RE: HARLOW STAGE 4 - AMENDMENTS TO CONSTRUCTION PLAN APPROVAL

Please be advised that the amended construction plans submitted to Council for Harlow Stage 4 are approved.

RE: HARLOW STAGE 4 - CONSTRUCTION PLAN APPROVAL

HARLOW ESTATE STAGE 4

CONSTRUCTION Drg No **309440R01**

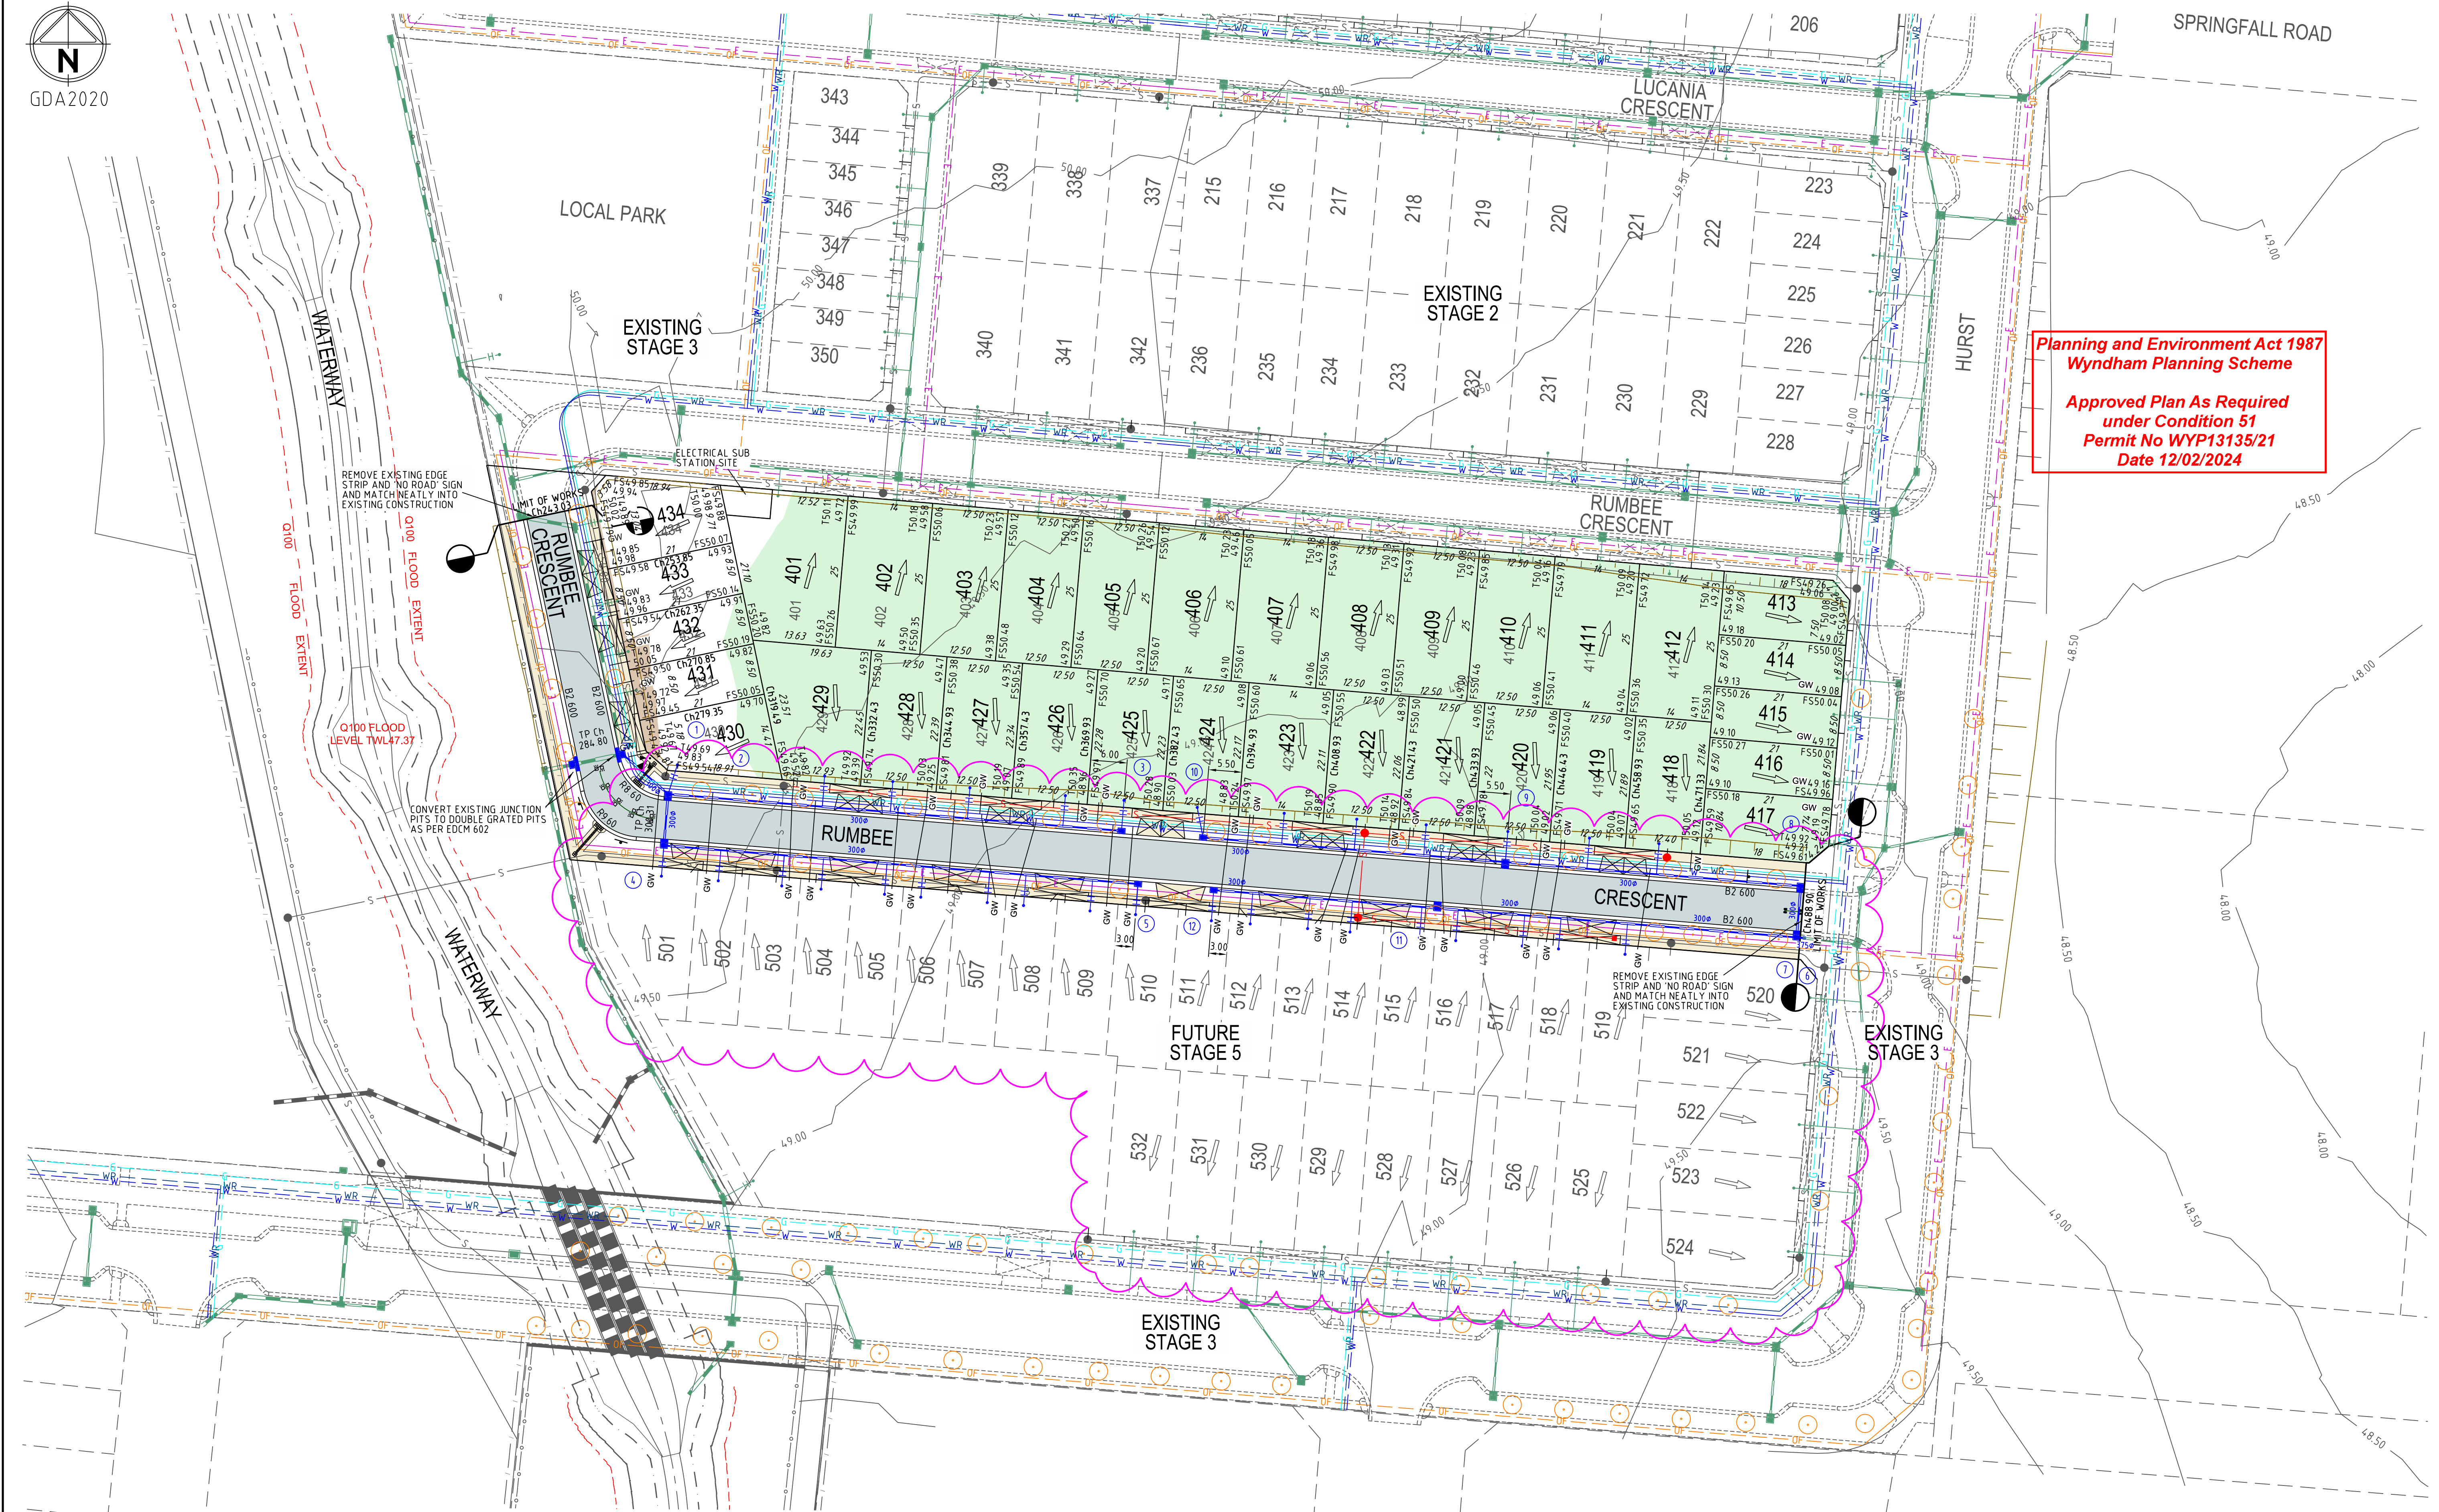
2	DRAWING SCHEDULE UPDATED R01, 06, & 07 UPDATED	M.R	09/02/24
1	DRAWING SCHEDULE UPDATED R01, 02, 06, 07, & 09 UPDATED	M.R	04/12/23
0	ISSUE FOR CONSTRUCTION	M.R	04/11/23
Rev	Amendments	Approved	Date
